Docket Number:	12-AFC-02
Project Title:	Huntington Beach Energy Project
TN #:	202084
Document Title:	Resolution from the City of HB Supporting Proposed Architectural Improvements for the HBEP
Description:	N/A
Filer:	Teraja Golston
Organization:	California Energy Commission
Submitter Role:	Commission Staff
Submission Date:	4/16/2014 8:41:59 AM
Docketed Date:	4/16/2014

**A RESOLUTION OF THE CITY COUNCIL OF THE
CITY OF HUNTINGTON BEACH SUPPORTING PROPOSED ARCHITECTURAL
IMPROVEMENTS AS MODIFIED AND APPROXIMATE 125 FOOT HIGH
STRUCTURES RELATED TO THE RECONSTRUCTION OF
THE HUNTINGTON BEACH ENERGY PROJECT**

Huntington Beach Energy Project

CONCEPTUAL LANDSCAPE PLAN
APPROXIMATE QUANTITY OF PROPOSED PLANTS

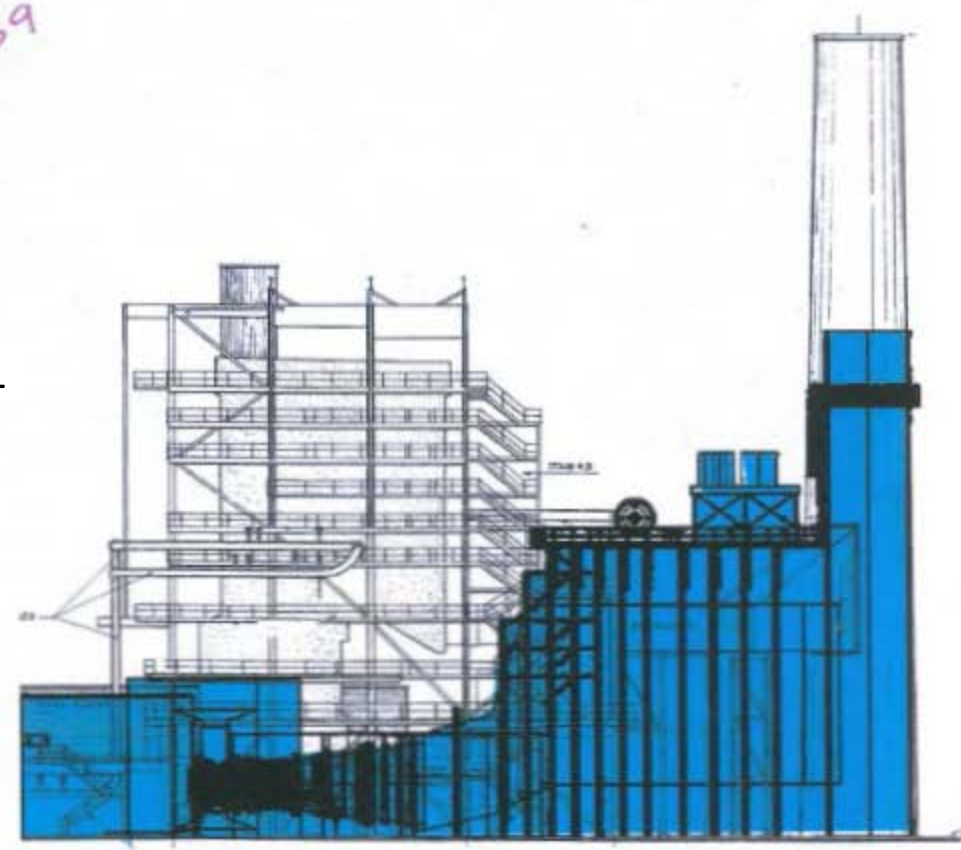
SECTION 5. The City of Huntington Beach City Council recommends that CEC's final action incorporate an architectural plan based on the visual simulations and architectural enhancements as depicted Exhibit A with the following modifications: 1. the surfboard design shall be substantially three-dimensional and of a sufficient size and proportion for a realistic representation of a surfboard; 2. the trompe l'oeil painting on the air cooled condensers be revised to be more reflective of resort hotel windows and hotel improvements; 3. The entire HBEP be painted a combination of tans and browns on the lower portions and light blue on the upper portions. 4. No signs or other identifying features be painted or attached to the stacks, air cooled condensers, or heat recovery steam generators; 5. The final architectural plan and color scheme shall be subject to review and approval by the Planning and Building Department.

- Building Height
 - Maximum 50 ft height in Public Semi-Public zone
 - Approximately 120 ft for six stacks
 - Approximately 125 ft for three surfboards
- Architectural Improvements: Recommended Revisions
 - Surfboards: substantially three-dimensional and of sufficient size and proportion for realistic representation of a surfboard
 - Trompe l'oeil painting on ACC: more reflective of resort hotel
 - Entire HBEP: painted combination of tans and browns on lower portions and light blues on upper portion
 - No signs or other identifying features on stacks, ACCs, or HRSGs
